Renard Mine

Increase in Ore Extraction and Processing Rate

Application to Amend the Global CA (3214-14-041) —
Additional Document — Answers to MELCC's Questions
and Comments dated September 6, 2019

October 2019

Carte / Map
1

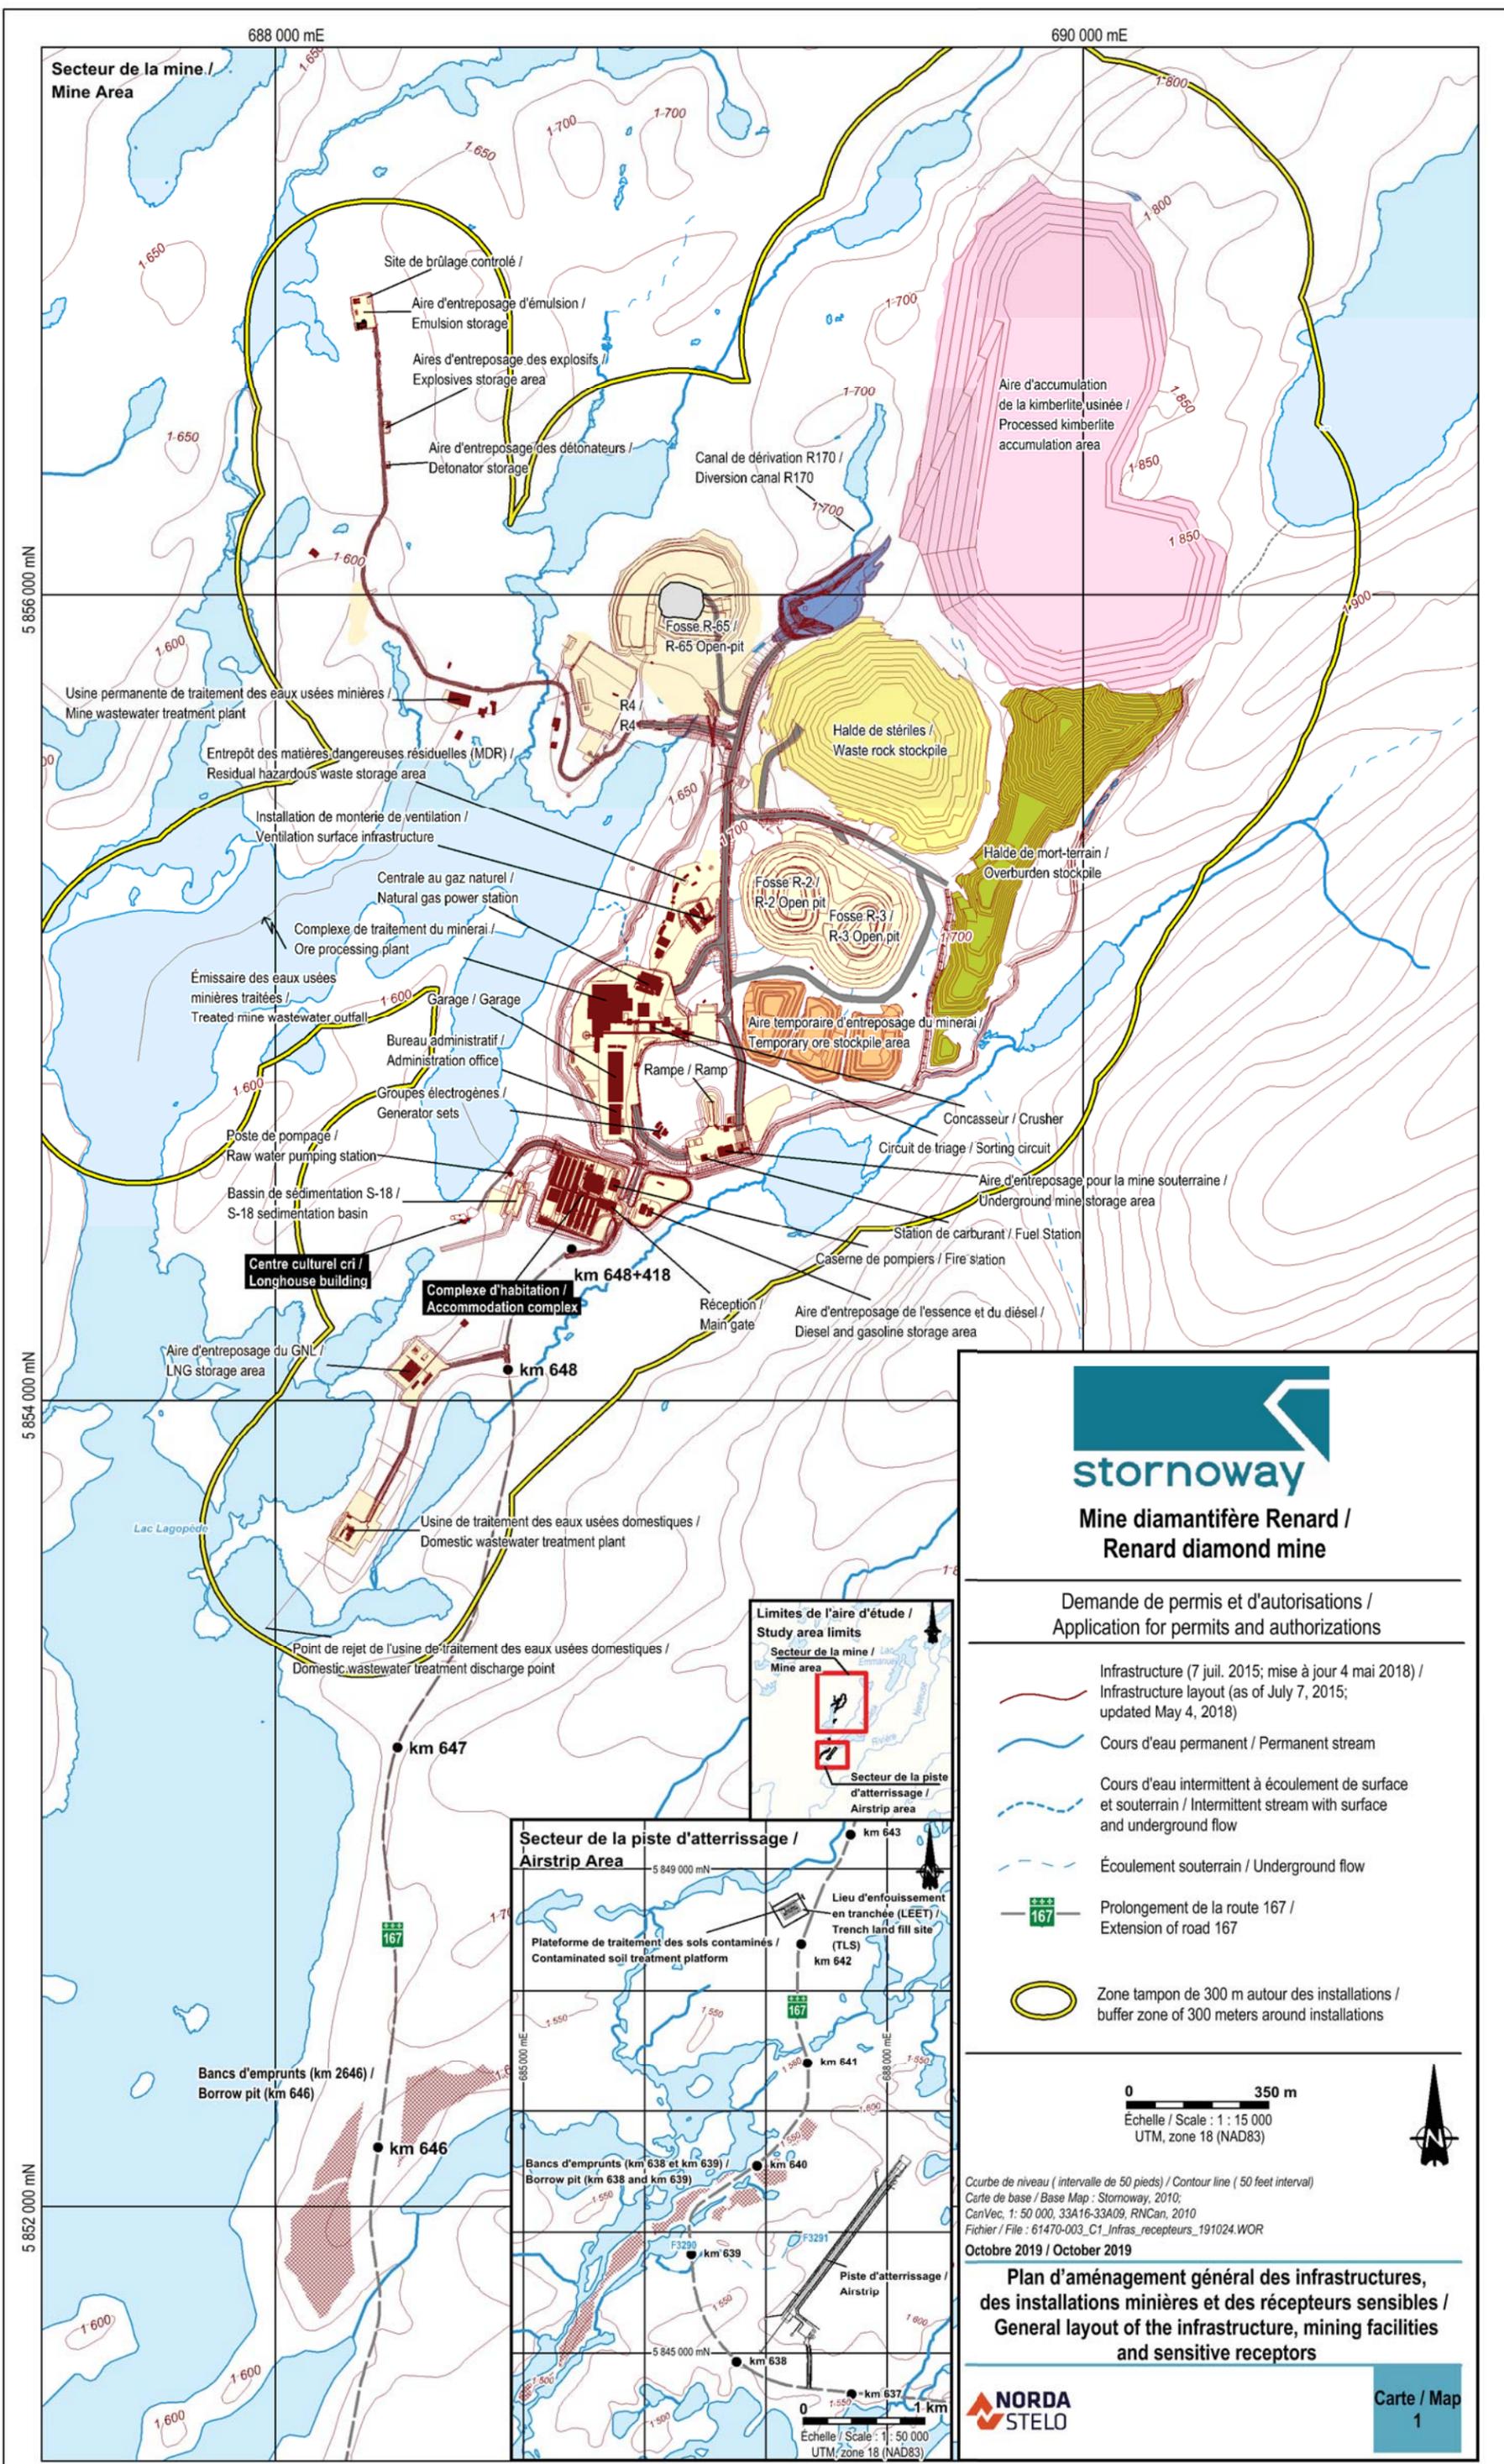
QC-4. Since the impact assessment was submitted, the procedure for assessing compliance with air quality standards and criteria has been reviewed for mining projects located on public lands. Compliance with standards and criteria is now verified at sensitive receptors, and the proponent is required to submit a map showing the location of sensitive receptors (e.g., permanent residences/camps, chalets, sites where traditional activities are carried out) in the modelling area, i.e., the roughly 10 km x 10 km area as defined in Appendix 2.2 of “Atmospheric Emissions Dispersion Modelling – Renard Diamond Mine Project – Ref. No.: 61470.012-200 – Final Version - December 2014” (hereinafter called the December 2014 dispersion study).

QC-5. In section 4 of the application to amend the certificate of authorization, it is indicated that the amount of dust produced by surface operations will be less than the levels observed from 2015 to 2017. It is however essential to bear in mind that the increase involves operations at pit R65, whereas 2015 to 2017 operations primarily involved operations at pit R2/R3. Owing to the different spatial distribution of the sources, it is difficult to compare operations in the 2015-2017 period to planned operations. It would be more appropriate to use a scenario that involves operations at pit R65 for the comparison.

The proponent should clearly demonstrate that amendments to the project are not likely to significantly increase the concentration of airborne contaminants at the sensitive receptors. The proponent should compare the main contaminant emission sources specified in the December 2014 dispersion model with those anticipated following amendments to the project. If the proponent is not in a position to demonstrate this, it should submit an update to the air emissions dispersion model that accounts for project amendments.

With regard to the Renard mine, the only sensitive receptors in the modelling zone are the workers accommodation complex and the Cree Cultural Center (Longhouse building) located within 300 m from the facilities. Within the 10 km by 10.5 km modelling area but more than 300 m from the facilities, no sensitive receptors were found. Map 1 indicates the location of these two receptors.

As indicated in the answer to question QC-4 above, there are no known receptors more than 300 m from the mining facilities. The only known sensitive receptors are located within the boundary of the mining facilities, i.e., the accommodation complex and the Cree Cultural Center (Longhouse building) (see Map 1).
